1st Further Information

**Proposed Temporary Warehouse (Excluding Dangerous Goods Godown) with Ancillary Facilities
and Associated Filling of Land for a Period of 3 Years in “Agriculture” Zone,
Various Lots in D.D. 91 and D.D.100, Lin Tong Mei, Fanling, New Territories**

(S.16 Planning Application No. A/NE-KTS/574)

Responses-to-Comments

Annex III
Landscape Proposal

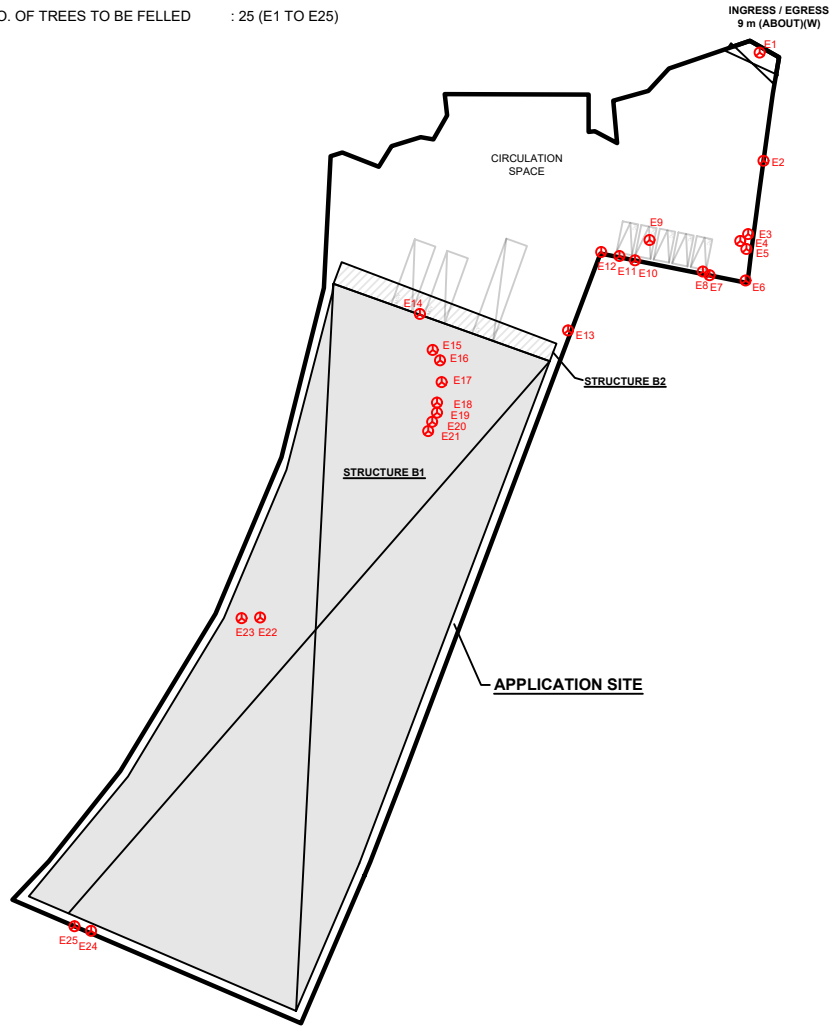
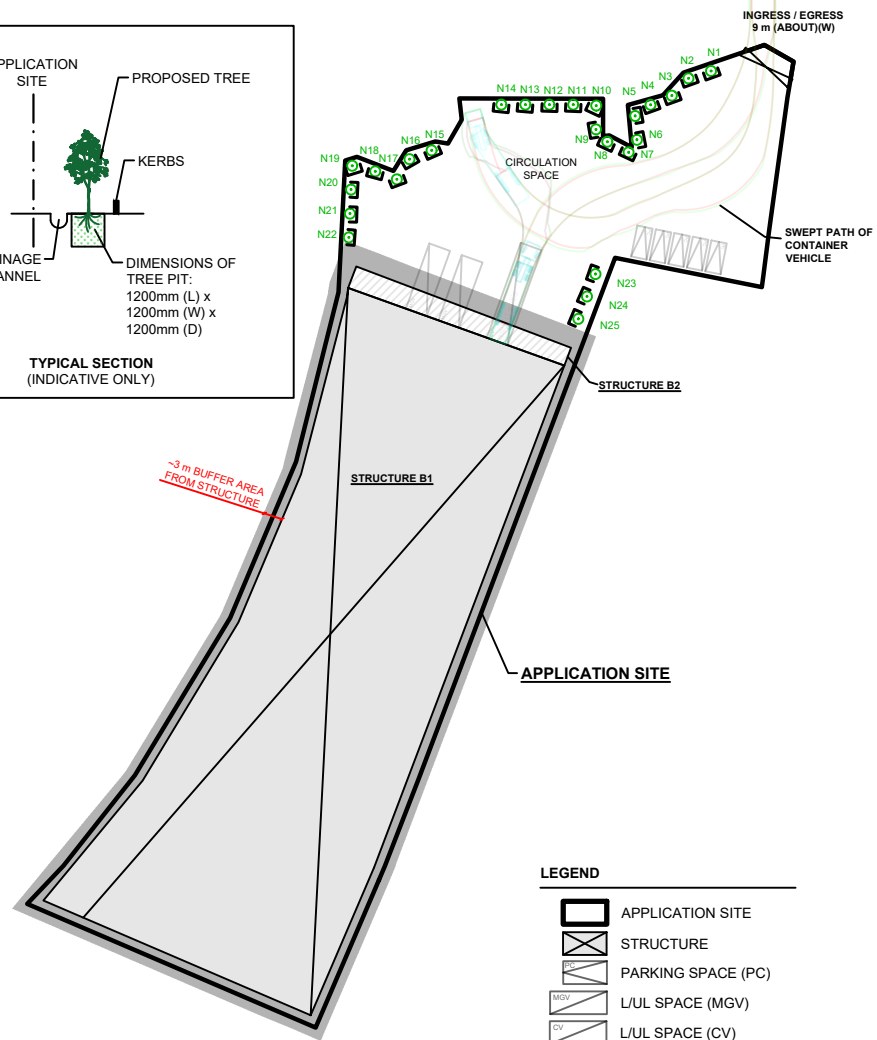
(a)	<p>With reference to DPO's site photos taken on 17.3.2026, the Site is largely vacant. Some overgrown vegetation and trees of common species are found on the Site. According to the Application Form, no tree felling will be involved. However, para 5.15 of the Planning Statement states that "...all existing trees within the Site will be affected, and it is not proposed to retain any of the existing trees at the Site.</p>	<p>The tree survey and landscape proposal are provided by the applicant for your consideration (Annexes II to III). According to the tree survey conducted on 11/2/2025, a total of <u>25</u> nos. of trees were recorded within the Site, within which no old and valuable tree or protected species has been identified in accordance with DEVB TC(W) No. 5/2020 – Registration and Preservation of Old and Valuable Trees and the Forests and Countryside Ordinance (Cap. 96) at the Site (Annex II). Due to proposed hard-paving works for erection of warehouse and vehicle circulation purposes, majority of the Site area will be disturbed; consequently, all existing trees within the Site will be affected, and it is not proposed to retain any of the existing trees at the Site.</p> <p>Due to felling of existing trees within the Site, a landscape proposal has been submitted by the applicant to provide landscape mitigation measures within the Site (Annex III). A total of <u>25</u> new trees is proposed to be planted along the northwest, north and northeast</p>

of the Site to minimize landscape and visual impact to the nearby areas. All the new trees will be maintained by the applicant during the planning approval period.

Plan 1

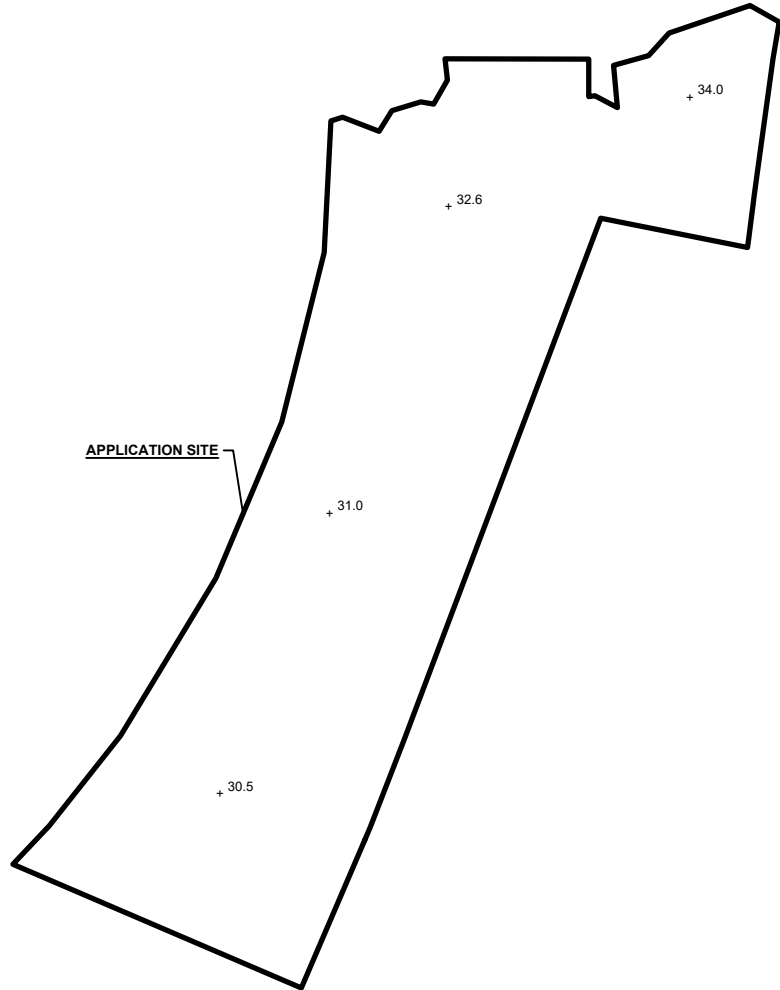
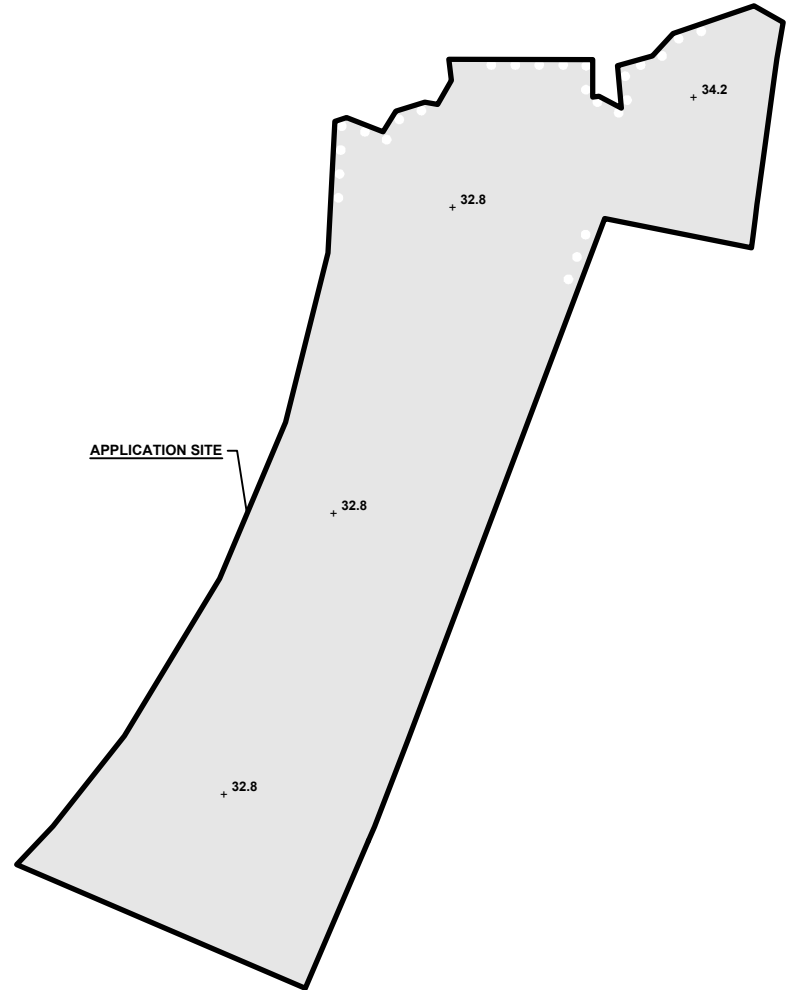
- A revised plan showing the filling of land of the Site is provided (**Plan 1** and **Annex I**). Majority of the Site (6,554m², 99%) is proposed to be filled with concrete of not more than 2.3m in depth for site formation of structures, parking and L/UL spaces and circulation area. The remaining area (i.e. 50m²) will be remained as soiled ground for healthy tree growth.
